Access Compliance Report

Public Rights-of-Way

Intersection ID: 10033070	Main Street: NORTH_COMMUNITY_HOUSE_RD	Cross Street: N/A	Location: E
ADA ID: 884413CF14D5	Ramp Type: Perp	Initial Pass/Fail: Pass	Overall Compliance: No
Codes/Mitigation Info/Possible Solution		Field Measurements/Component Compliance	
Severity Score: 5

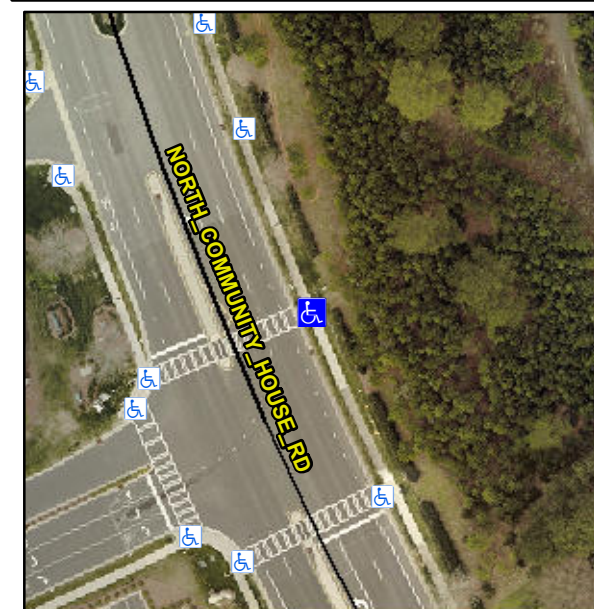
PROW/ADA:

Not Found, R304.5.4, R304.5.3

Possible Solutions:

**Remove & Replace Entire Ramp.
Remove & Replace Gutter.**
